UNITED STATES PATENT AND TRADEMARK OFFICE

| APPLICATION NO. | FILING DATE | FIRST NAMED INVENTOR | ATTORNEY DOCKET NO. | CONFIRMATION NO. |
|-----------------|-------------|----------------------|---------------------|------------------|
| 10/765,583 | 01/27/2004 | Thomas L. Toth | GEMS8081.196 | 1715 |

**TITLE: SYSTEM AND METHOD OF DETERMINING A CENTER OF MASS OF AN IMAGING SUBJECT
FOR X-RAY FLUX MANAGEMENT CONTROL**

Replacement Sheet 1 of 3

FIG. 18

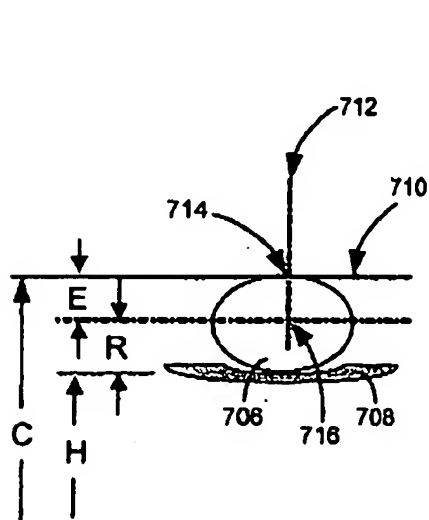
1. The drawings are objected to because of the following: (equation " $E=R+H-C$ " not corresponding to fig. 18) and (equation " $E=C-R-L$ " not corresponding to fig. 19). The equation " $E=R+H-C$ " is equivalent to $E+C=R+H$. However, as seen in Figure 18, $E+C$ does not equal $R+H$. Likewise, the equation " $E=C-R-L$ " is equivalent to $E+R+L=C$. However, as seen in Figure 19, $E+R+L$ does not equal C .

Corrected drawing sheets in compliance with 37 CFR 1.121(d), or amendment to the specification to add the reference character(s) in the description in compliance with 37 CFR 1.121(b) are required in reply to the Office action to avoid abandonment of the application. Any amended replacement drawing sheet should include all of the figures appearing on the immediate prior version of the sheet, even if only one figure is being amended. Each drawing sheet submitted after the filing date of an application must be labeled in the top margin as either "Replacement Sheet" or "New Sheet" pursuant to 37 CFR 1.121(d). If the changes are not accepted by the examiner, the applicant will be notified and informed of any required corrective action in the next Office action. The objection to the drawings will not be held in abeyance.
